**BEFORE THE WASHINGTON UTILITIES AND
TRANSPORTATION COMMISSION**

Puget Sound Energy's 2013 Integrated
Resource Plan Work Plan pursuant to
WAC 480-100-238

Docket UE-120767

SIERRA CLUB COMMENTS

Figure 1: Resource Builds by Scenario

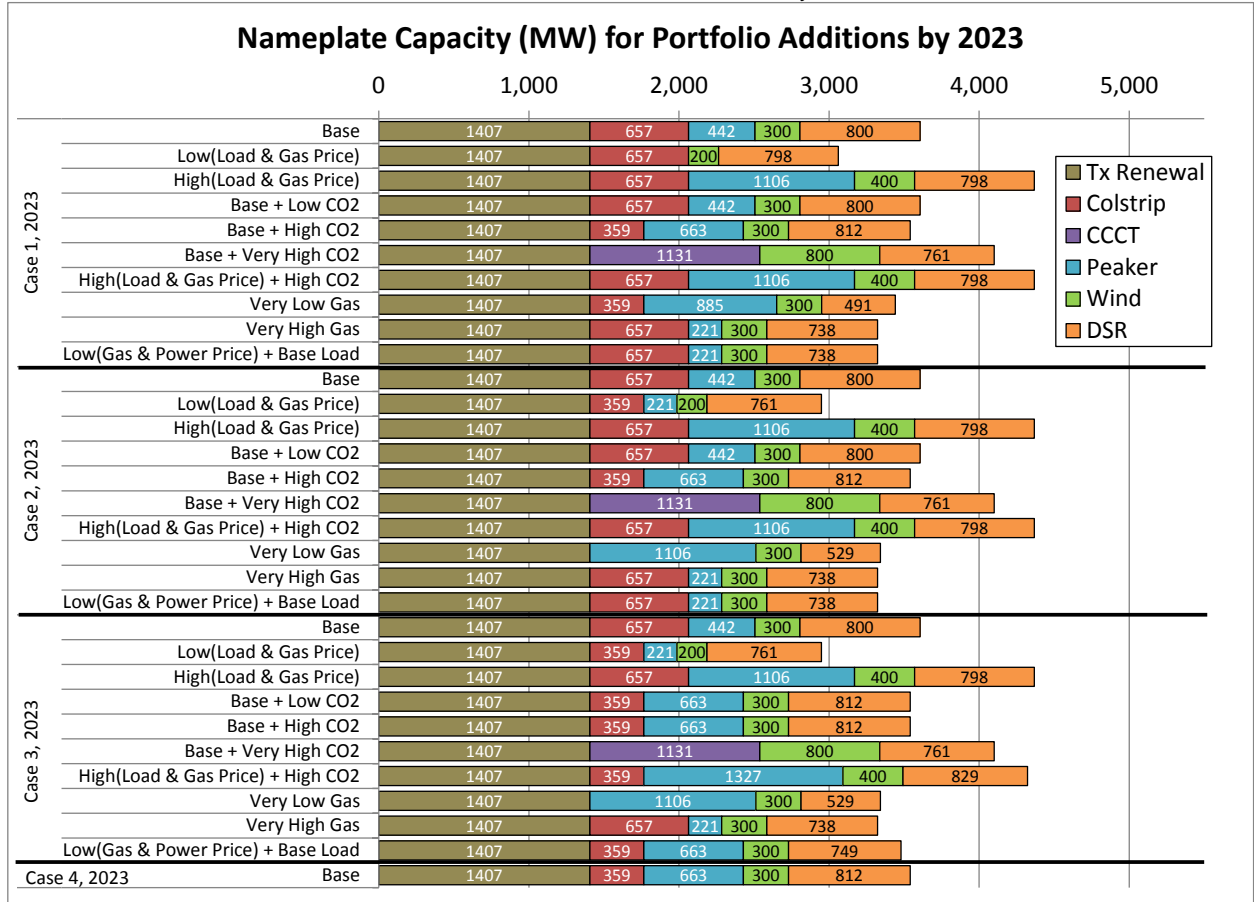
30. PSE generally concludes that continued reliance on Colstrip to provide electricity reduces cost and market risks for customers. This conclusion is overly simplistic and misleading because it fails to account for the significant risks, particularly at Units 1&2, that customers face under many of the scenarios. As noted above, to the extent that PSE's results for Units 1&2 can be disaggregated from the results for Units 3&4, it is clear that the results for these two pairs of units are very different. This is evident in Figure 1, below, which shows a snapshot of PSE's expected resource mix under various scenarios

31. Figure 1 shows that the relative economic costs and benefits of Colstrip are very different between Units 1&2 and Units 3&4. The red bars in Figure 1 represent PSE’s share of Colstrip’s capacity, up to a maximum of 657 MW. If the entire 657 MW bar remains, this means that the model found it economical to continue to operate all four Colstrip units. If only a 359 MW red bar is shown, then the model replaced Colstrip Units

1&2 in 2017. If there is no red bar for Colstrip, then the model replaced all four Colstrip units in 2017. Figure 1 shows that it is more economical to replace Units 1&2 in a large proportion of the scenarios (15 out of 31). Units 3&4 are also replaced under very low gas prices or very high CO₂ prices.¹² Despite this clear divergence between the pairs of units, for most of Chapter 5 in the IRP PSE treats Colstrip as a single resource, and the analysis compares costs with and without the entire plant. This raises the question of how each of these results and graphs would look if PSE treated Units 1&2 separately, a question the IRP does not address.

Figure 2: Annual Revenue Requirement in Base Scenario
 Source: PSE, Final IRP, Figure 5-24

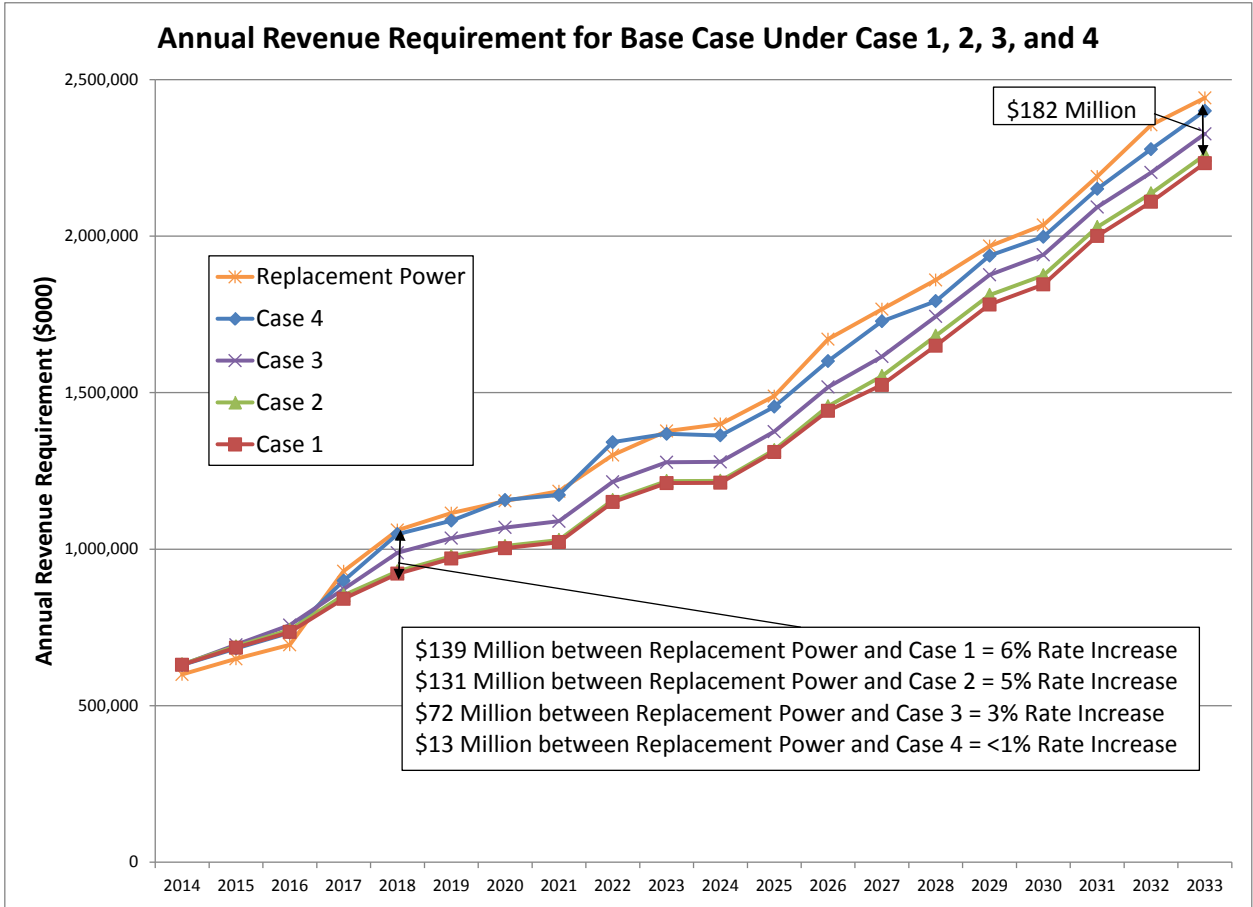
33. The results presented by PSE in Figure 2 show only the overly-conservative “Base” scenario. Figure 2, and PSE’s conclusions based on this figure, are therefore biased in favor of retaining Colstrip. In reality, it is very unlikely that PSE will face a \$0 cost for CO₂. The rate impacts shown in Figure 2 are therefore higher than what would plausibly be expected, and a more realistic analysis would reduce or even eliminate the cost of replacing all four Colstrip units.

34. The analysis presented in Figure 2 also does not conform with the IRP standards required by Washington law. WAC 480-100-238 requires to make, “a plan describing the mix of energy supply resources and conservation that will meet current and future needs at the lowest reasonable cost.”¹⁴ The definition of “lowest reasonable cost” includes “the

cost of risks associated with environmental effects including emissions of carbon dioxide.”¹⁵ PSE has not met this standard because the IRP’s analysis and the final choice of resource mix were premised on the base case scenario, which assumes a \$0 cost of carbon. Simply modeling a carbon price, and then ignoring it throughout PSE’s preferred case, does not meet the requirements of WAC 480-100-238. PSE must base its plan on a reasonable carbon cost. If it had, the revenue requirement differences presented in Figure 2 would be very different.
